Pittwater House - DA2019/1274

I refer to a request from Neerson Murcutt Architects Pty Ltd for a response to the traffic and parking components of the issues raised in your email dated 1 May 2020. The responses are outlined below.

Table 2. ABS Travel to Work data.

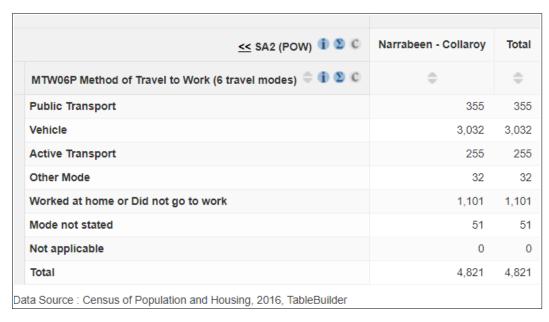
- Further, with regard to the existing parking shortfall, it is important to consider the following.
 - As reported in the TPIA, the existing off-street parking areas are underutilised. The surveys on different days showed many vacant spaces in the car parks. A review of available historical aerial images from Google Maps and NSW DFSI's SIX Maps consistently shows levels of car park underutilisation similar to those recorded by the surveys conducted by TEF Consulting.
 - Whilst the exact information about the staff travel modes is unavailable from the school, Australian Bureau of Statistics (ABS) provides Travel to Work data for Collaroy LG2 which is presented below. Travel modes for people working in this area (including the Pittwater House Schools), are as follows.

Removing those "worked at home" from the above data, the resulting travel mode splits would be as follows:

•	public transport	9.5%
•	vehicle	81.4%
•	active transport	6.8%
•	other/not stated	2.2%

- Based on the above percentages, the number of staff travelling by car on a daily basis is estimated to be 113 people. Some of these would be passengers / drop-offs, however for the worst case scenario it can be assumed that they are all drivers.
- With 76 car spaces provided on site the current deficiency is estimated as 113 76 = 37 spaces.
- The additional 5 staff will generate parking demand for 4 cars. With the additional 32 spaces provided, the deficiency will reduce to (113+4) (76+31) = 10 spaces. This is a significant improvement compared with the current situation.
- It is noted that Council's DCP requires one (1) car space for each staff member. This rate is highly unrealistic, as evidenced by the ABS data.
